REPORT TO: PLANNING and ZONING COMMISSION
FROM: MICHAEL S. GARRIGAN, AICP, CNU-A, Community Development Director
DATE: July 7, 2017
SUBJECT: REPORT TO PZB

CASE: Skipper Buds
17-08

REQUEST: Site Plan Review, Phase I

LOCATION: 1000 Route 173

Architecture

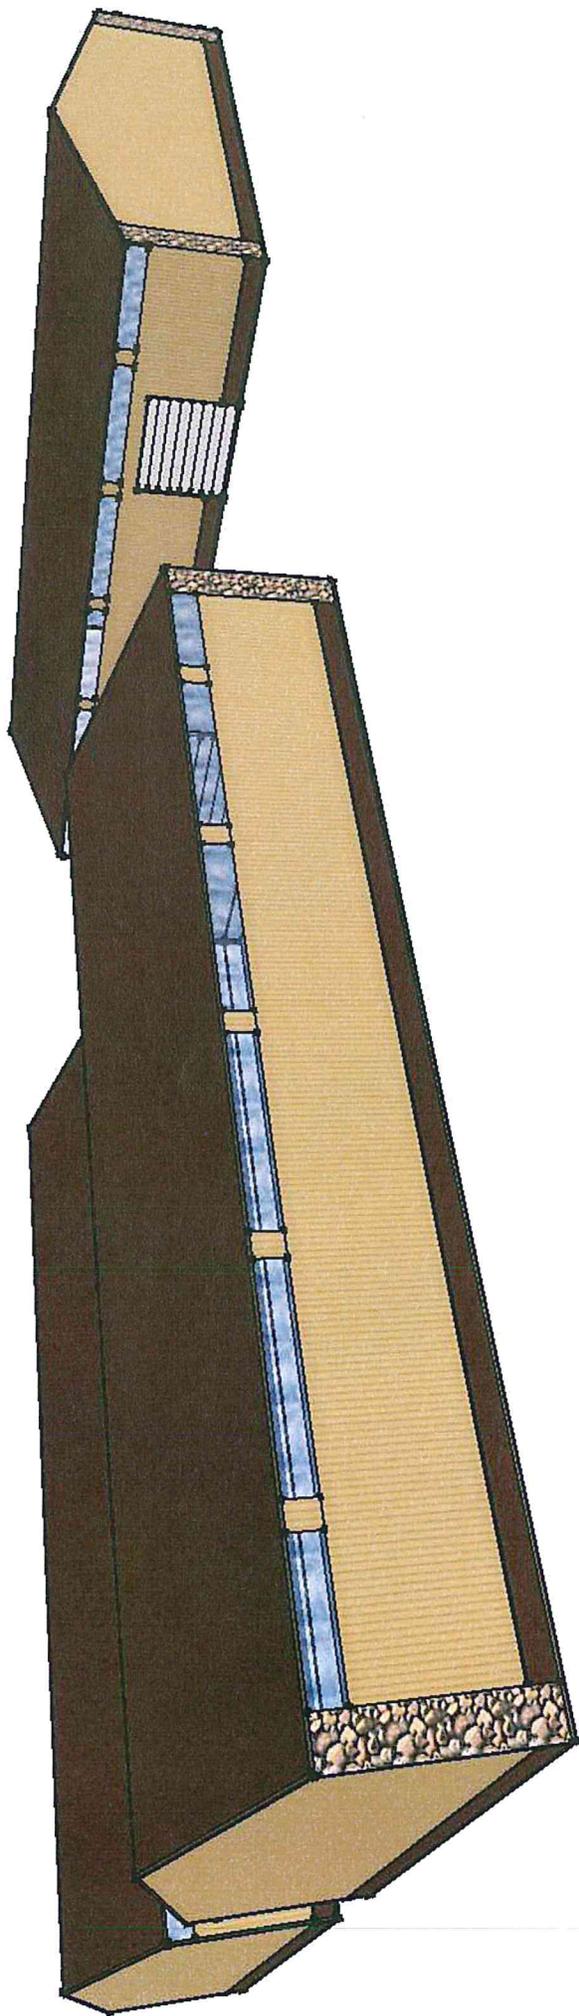
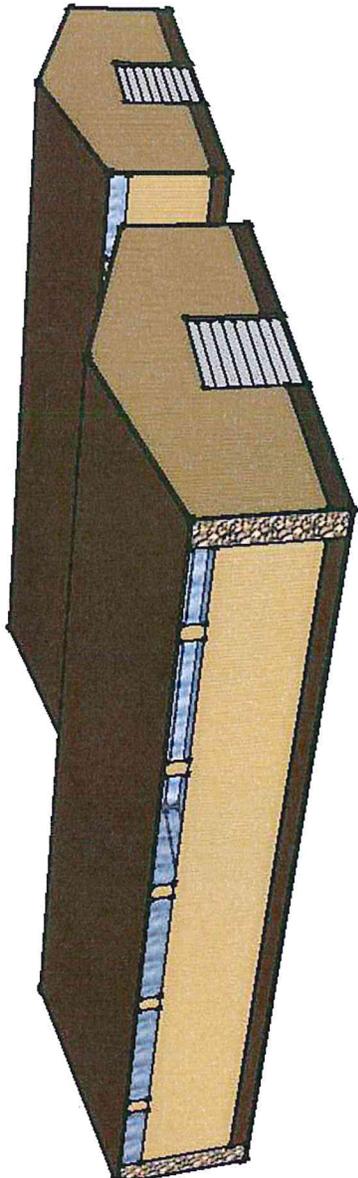
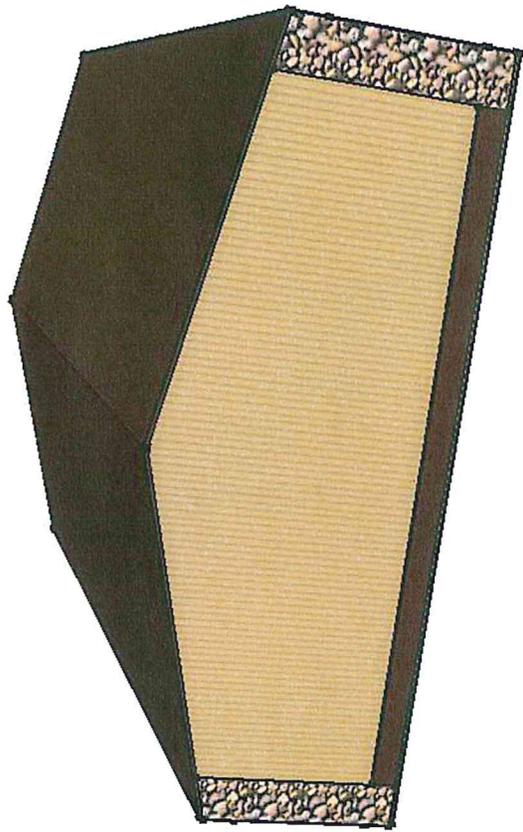
The applicant consistent with the Annexation Agreement is proposing to construct three pre-engineered metal storage buildings. Each building would incorporate a wainscot of block and a series of cultured stone pilasters to break up the massing of the building. In addition, each building would contain a series of windows along the roof-line to provide natural light into each building.

P17-0040 3 SKIPPER BUDS SITE AND UTILITY PLAN 0617.dwg Default 6/29/2017 7:24:28 AM

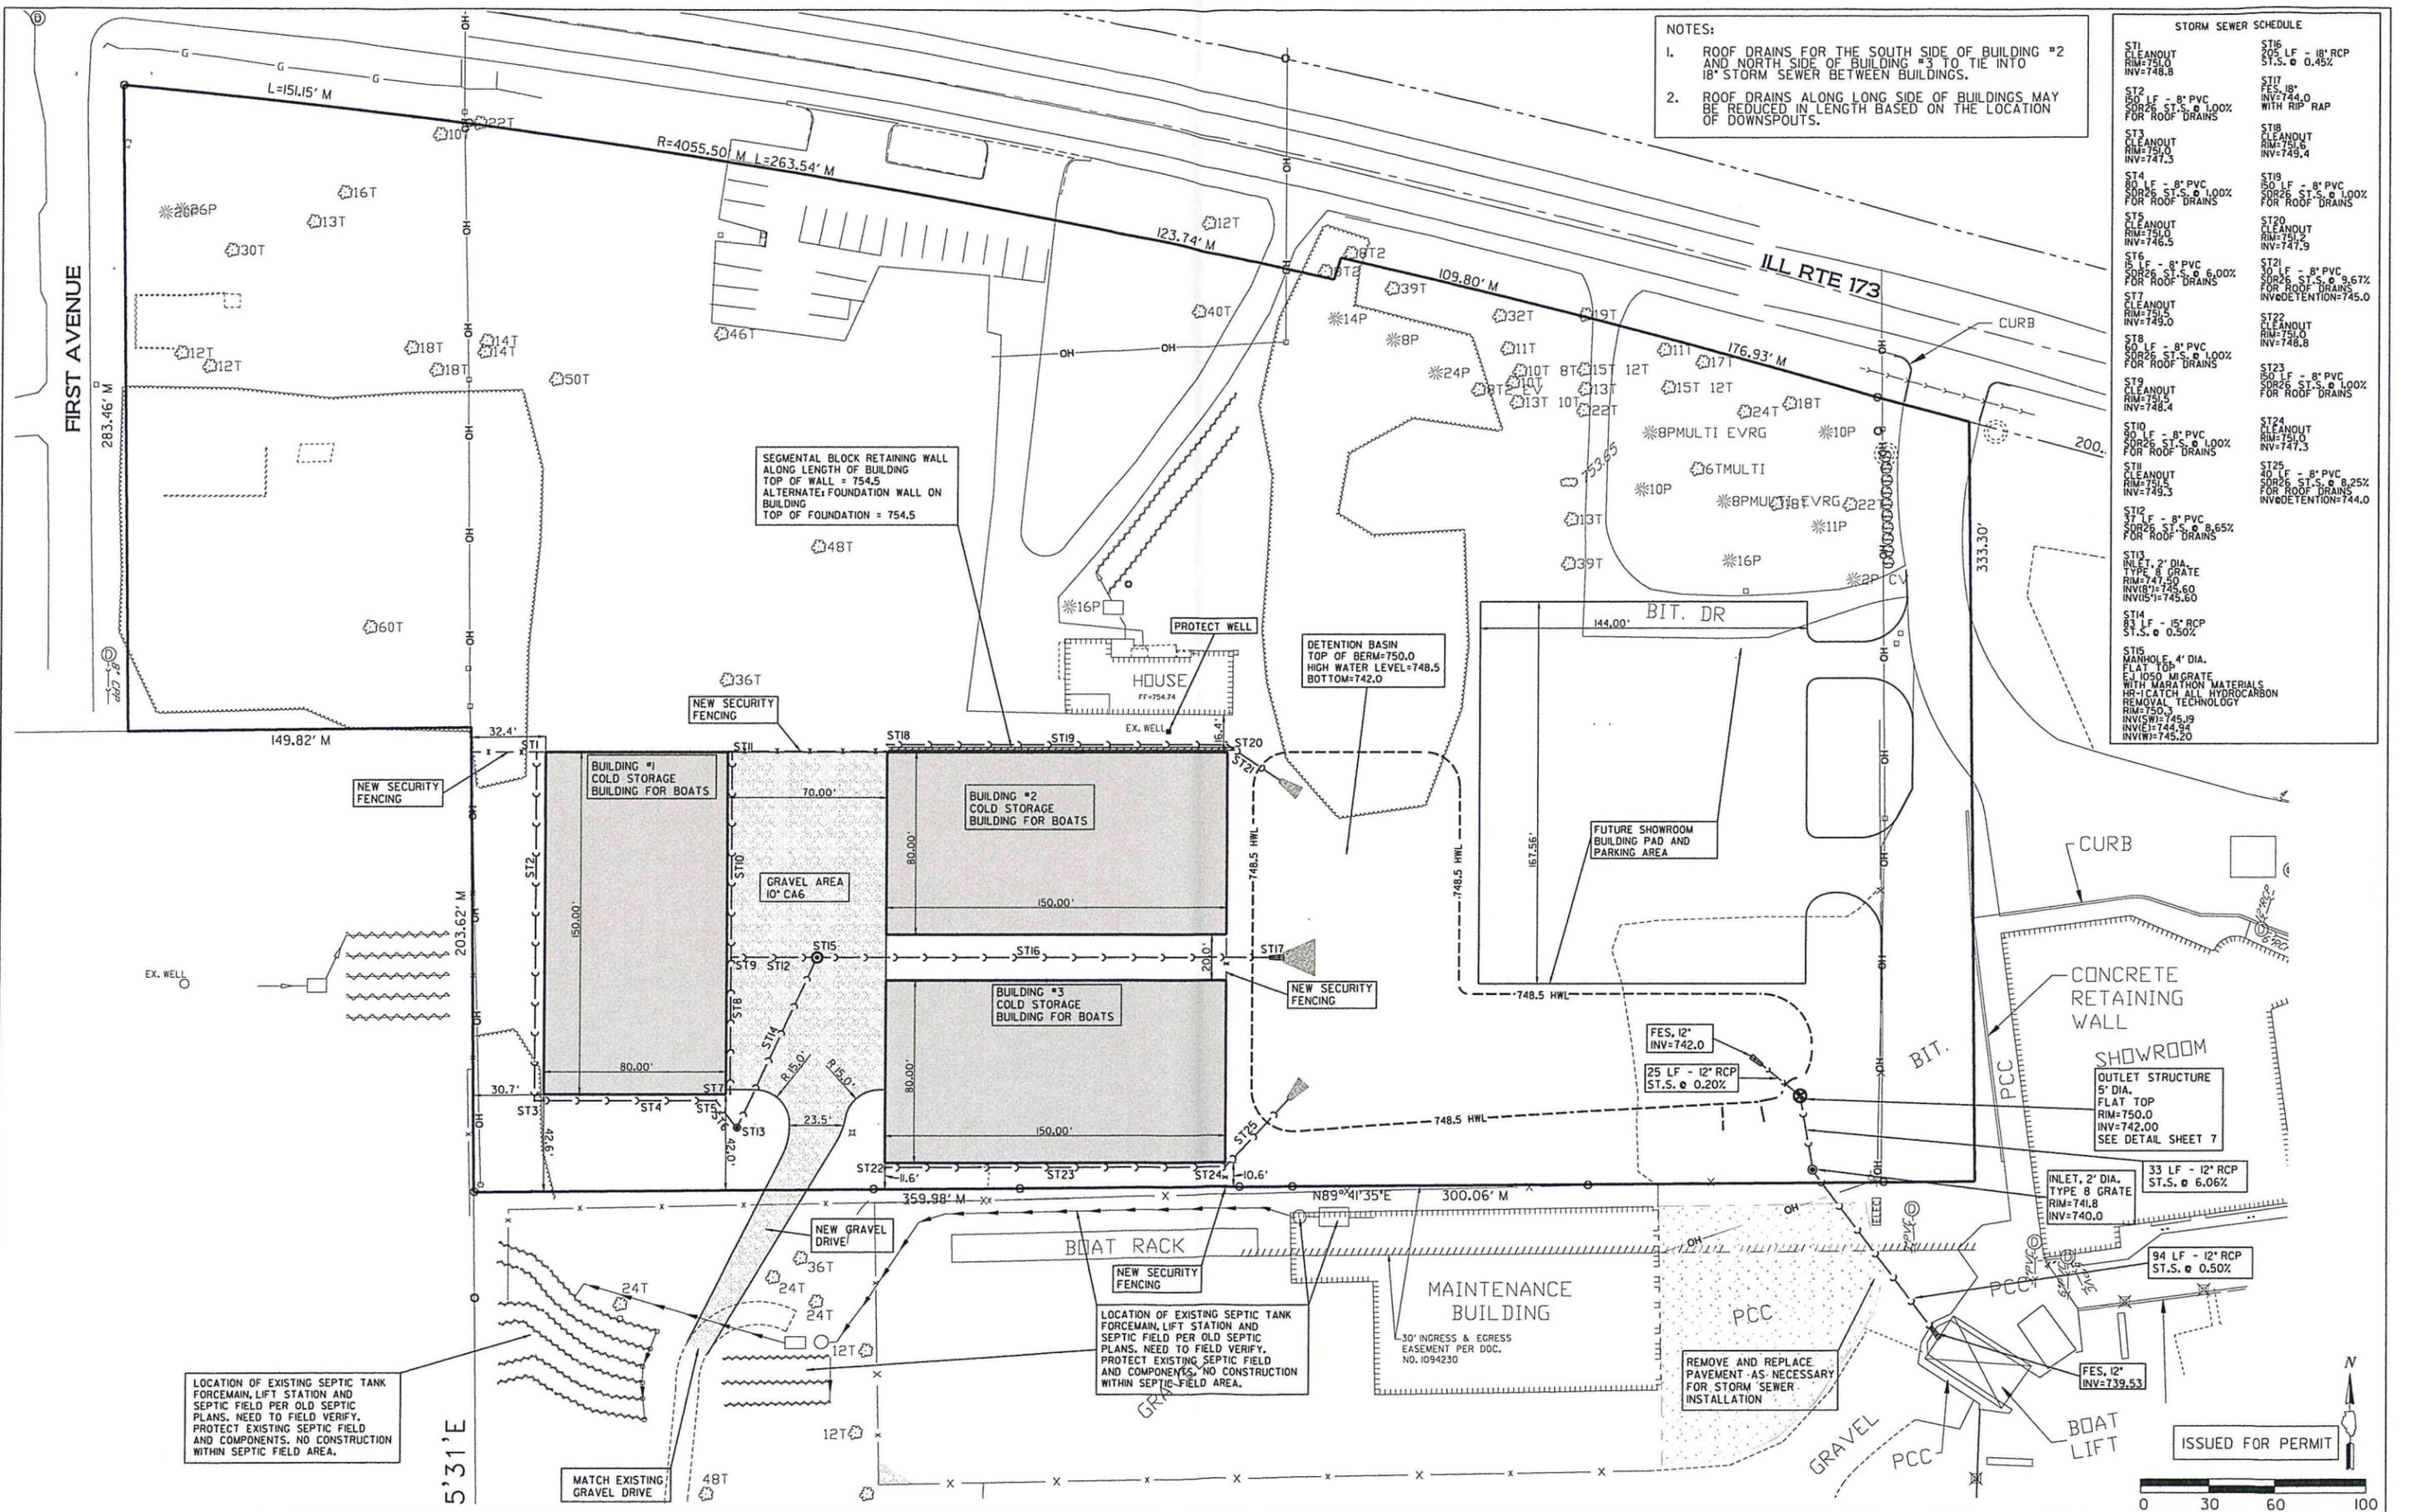
- 1. Compliance with the requirements of the Village Engineer.***
- 2. Compliance with the requirements of the Plainfield Fire Protection District.***
- 3. Submittal of a revised landscape plan as per the recommendations by Staff.***
- 4. Any lighting fixture wall pack shall comply with Village Ordinance as it relates to being set at a ninety degree angle towards the ground.***
